7380 J-722 SH 1 5

DECTEL
 AND ASSOCIATED COMPANIES
 ENCLAVE PLANT BLDG 1 & 2
 COMMERCIAL POWER COMPANY
 ESFAS STATUS DISPLAY
 ICA
 CHAN A
 7380 J-722 SH 1 5

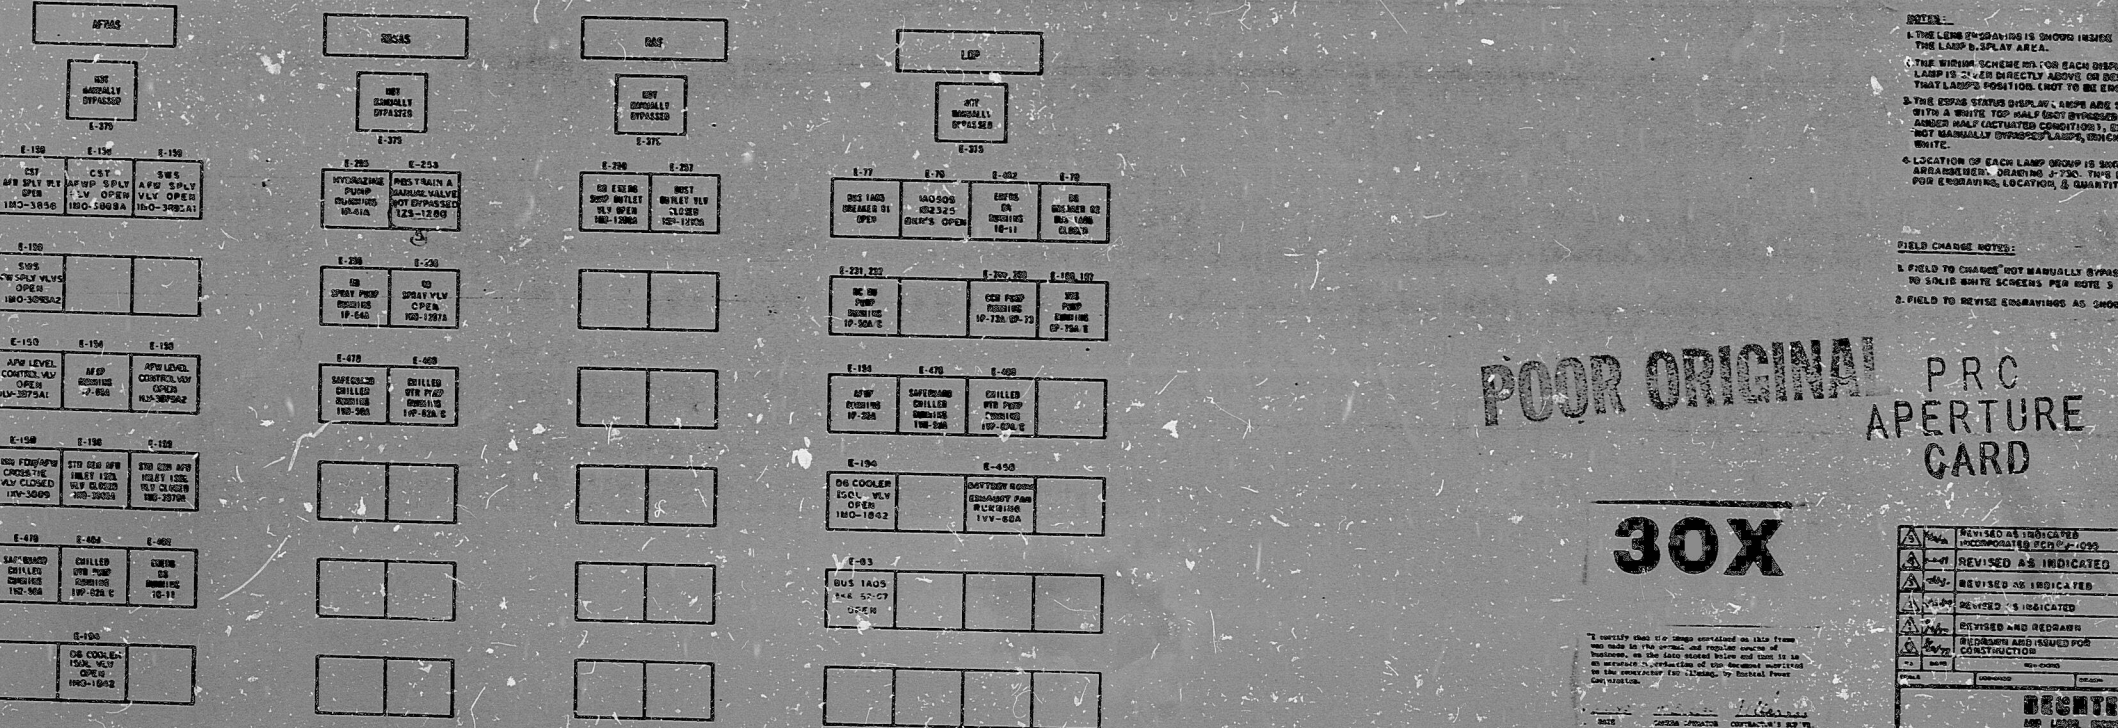
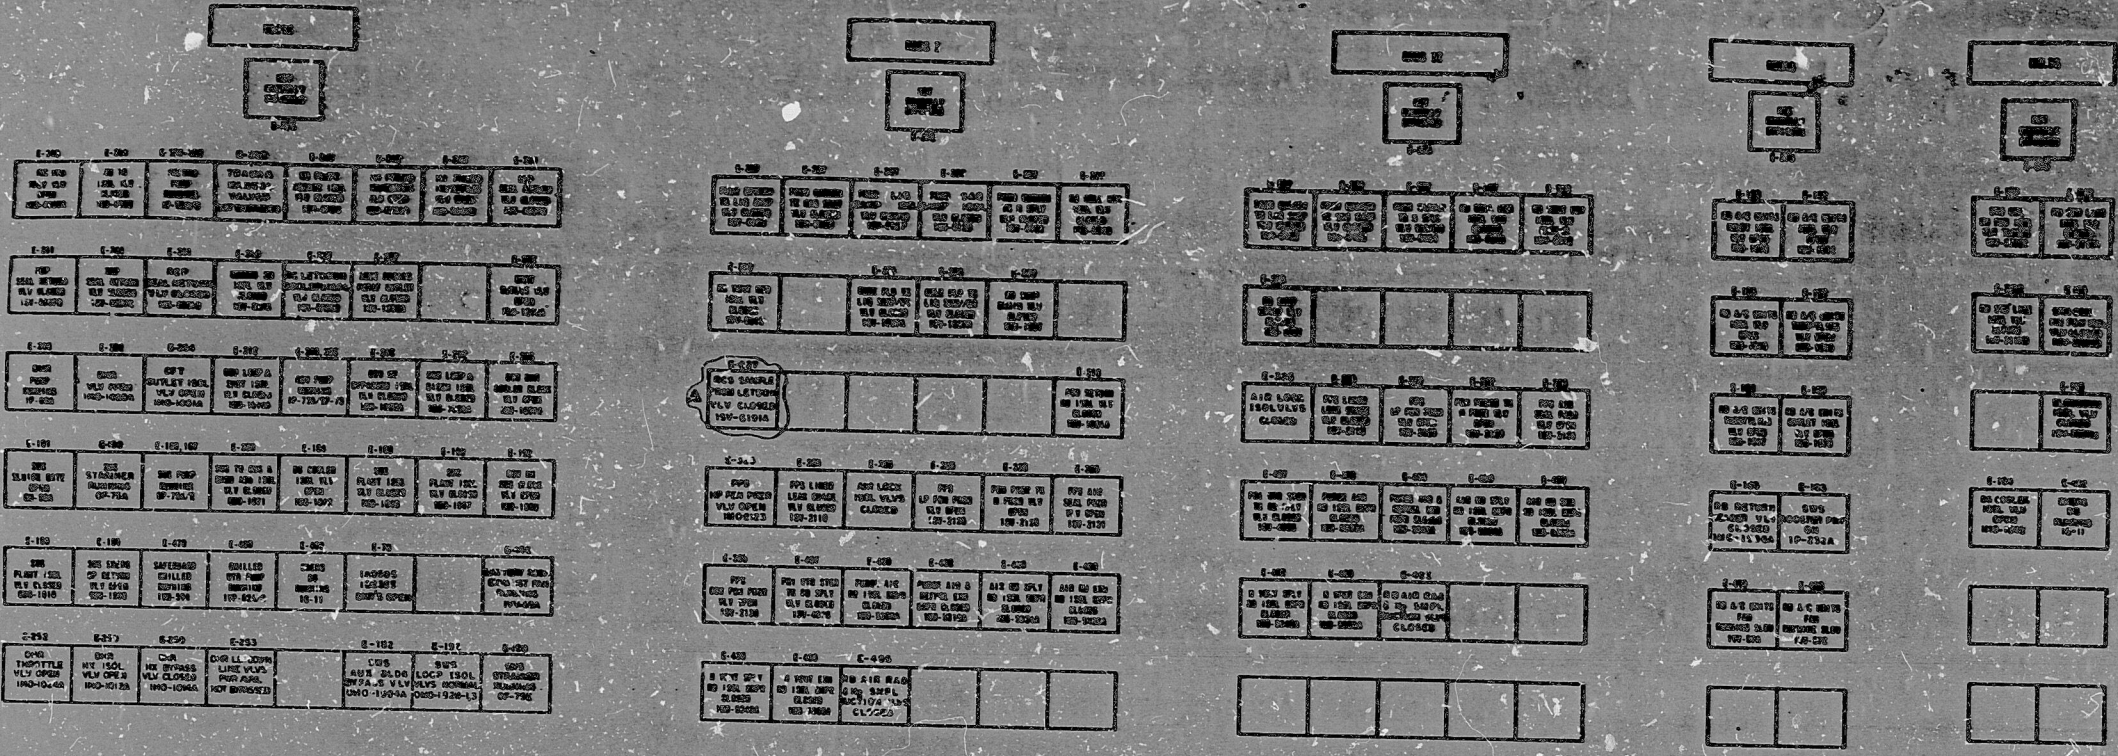
- FIELD TO CHANGE "NOT MANUALLY OPERATED" SPILT SCREEN TO SOLID WHITE SCREENS PER NOTE 3 ABOVE.
- FIELD TO REVISE ENGRAVINGS AS SHOWN.
